Index No. 149/12  
(Walsh, J.)

**AFFIDAVIT OF  
ANDREW  
WILLINGHAM, P.E.  
IN SUPPORT OF  
VERIFIED PETITION  
AND COMPLAINT**

Re: Patrick Farm Site Plan / Subdivision  
State Routes 202 & 306  
Town of Ramapo, New York  
**Technical Evaluation of Project Documents**

DATE	DRAWN BY
12/09/11	AVW
PROJECT NO.	
80039	
SHEET NO.	
W-2

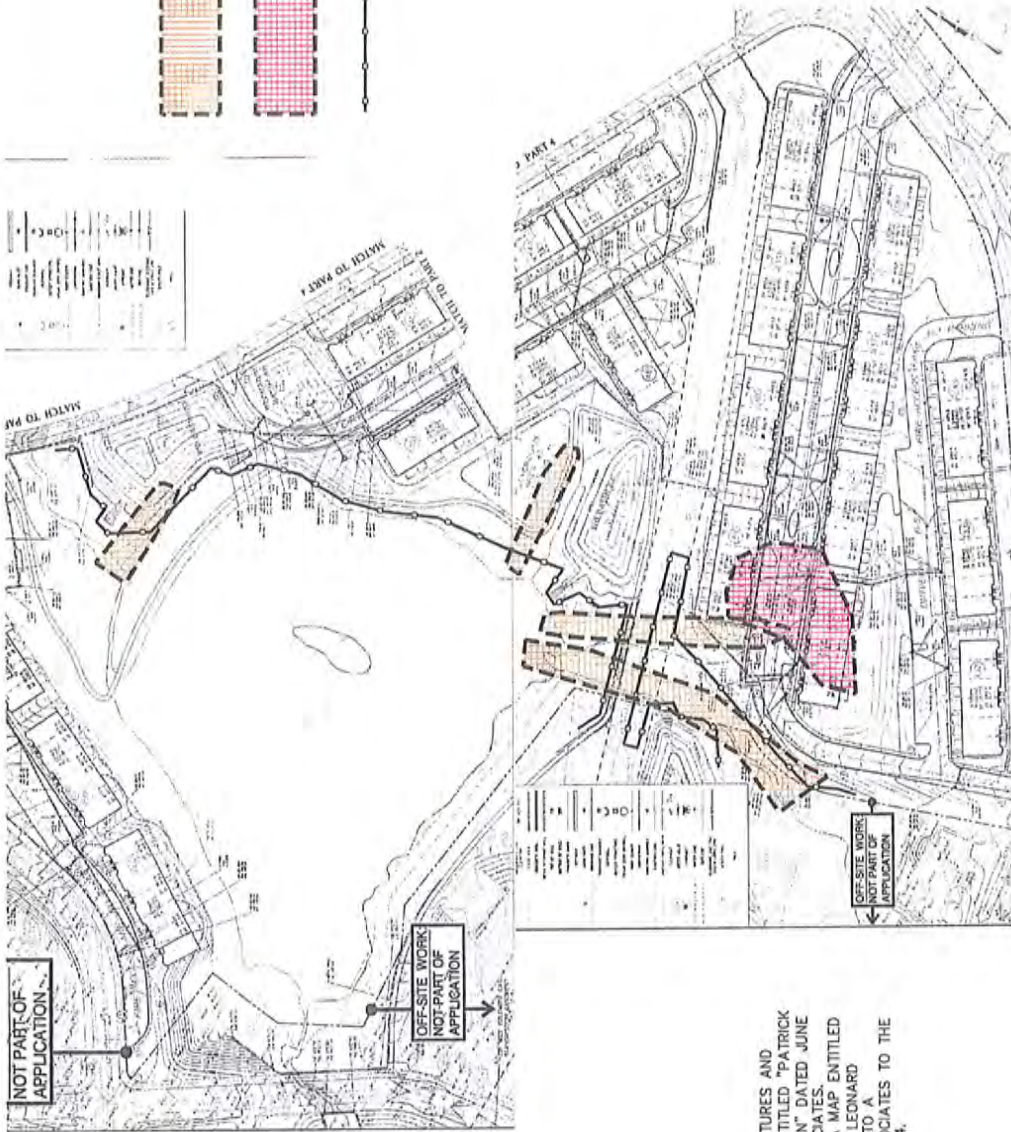
32. The Court is respectfully referred to the map attached to my December 21<sup>st</sup> Submission, entitled “W-2 – Wetland Disturbance – Pond Area”, which superimposes the areas identified as wetlands on the Applicant’s 2004 sketch submission to ACOE onto the current Site Plans.

34. Map W-2 clearly shows not only that these regulated wetland areas are erroneously missing from the Site Plans, but, moreover, they are proposed to be disturbed by the development.

44. As shown on Map W-2, again, an ACOE wetland is identified to be directly under

proposed parking areas and a building proposed as part of the Patrick Farm development.

48. By way of example, I again refer the Court to Map W-2, which we prepared. This Map shows that the roads and residential structures would be developed in ACOE wetlands.

These same areas identified as wetlands in the Leonard Jackson Associates sketch are not identified as regulated wetlands on the current development plans. Please see the attached map entitled "W-2 – Wetland Disturbance – Pond Area", prepared by this office. We have superimposed the areas identified as wetlands on the Leonard Jackson Associates sketch onto the current Site Plans. The map clearly shows that these regulated wetland areas are not only erroneously missing from the Site Plans, they are proposed to be disturbed by the development. It must be clarified as to how certain areas would warrant a cease and desist order from the ACOE for their disturbance, whereas these exact same areas are not identified and subsequently regulated as ACOE wetlands on the current plan.

ACOE wetland boundaries were also taken from National Wetland Inventory Mapping, which is published by the United States Fish and Wildlife Service. As shown on map W-2 , an ACOE wetland is identified to be directly under parking and a building proposed as part of the Patrick Farm development. Clearly, the wetland delineation on the plans is inaccurate and must be amended to accurately show wetland areas and the proposed disturbance.
